Access Compliance Report

Public Rights-of-Way

Intersection ID: 3757	Main Street: DAVIS_LAKE_PY	Cross Street: POPLAR_GROVE_DR	Location: NE
ADA ID: CEEC3787E079	Ramp Type: Perp	Initial Pass/Fail: Pass	Overall Compliance: No
Severity Score: 27.5			
Codes/Mitigation Info/Possible Solution		Field Measurements/Component Compliance

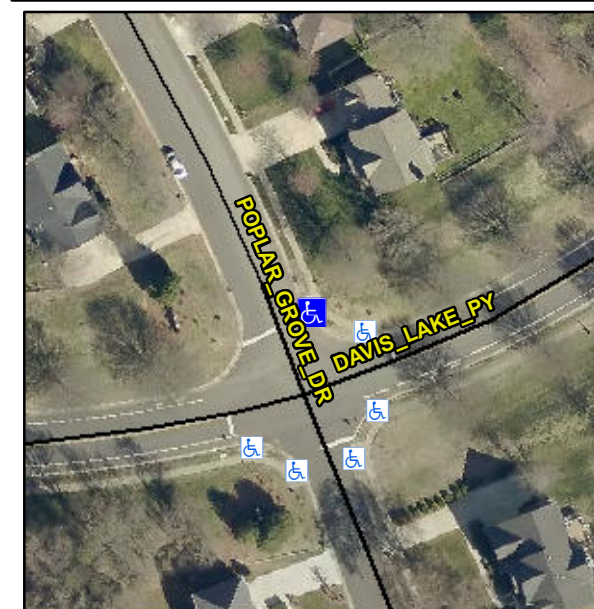
**Not Found, R304.2.2, R304.2.1,
R304.2.2-Perp, R304.3.2-Para,
R304.5.3, R305, R304.5.4**

Compliance	Description	Data	Compliance	Description	Data
N/A	Ramp Length (in)	93.0	No	Ramp Slope (%)	9.4
Yes	Ramp Width (in)	48.0	Yes	Ramp XSlope (%)	0.6
N/A	Flare Type LT	Sloped	N/A	Flare Type RT	N/A
N/A	Flare Slope LT (%)	8.2	Yes	Flare Slope RT (%)	2.9
N/A	Flare Traversable LT?	Yes	N/A	Flare Traversable RT?	Yes
No	Landing Length (in)	N/A	No	DWS Provided?	No
No	Landing Width (in)	N/A	N/A	DWS Contrast?	No
No	Landing Slope (%)	N/A	N/A	DWS Length (in)	N/A
No	Landing X Slope (%)	N/A	N/A	DWS Full Width?	No
N/A	Landing Curb? (Y/N)	No	N/A	DWS Offset (in)	N/A
N/A	Shared Landing?	No			
Yes	Gutter Ponding?	No	No	Gutter Slope (%)	6.8
Yes	Gutter Lip Ht (in)	0.0	Yes	Gutter X Slope (%)	0.1
N/A	Painted X Walk1?	No	N/A	Painted X Walk2?	N/A
	X Walk 1 Direction	To W		X Walk 2 Direction	N/A
N/A	X Walk 1 Width (in)	N/A	N/A	X Walk 2 Width (in)	N/A
	X Walk 1 Slope (%)	1.3		X Walk 2 Slope (%)	N/A
	X Walk 1 X Slope (%)	1.8		X Walk 2 X Slope (%)	N/A

**Remove & Replace Entire Ramp.
Remove & Replace Gutter.**
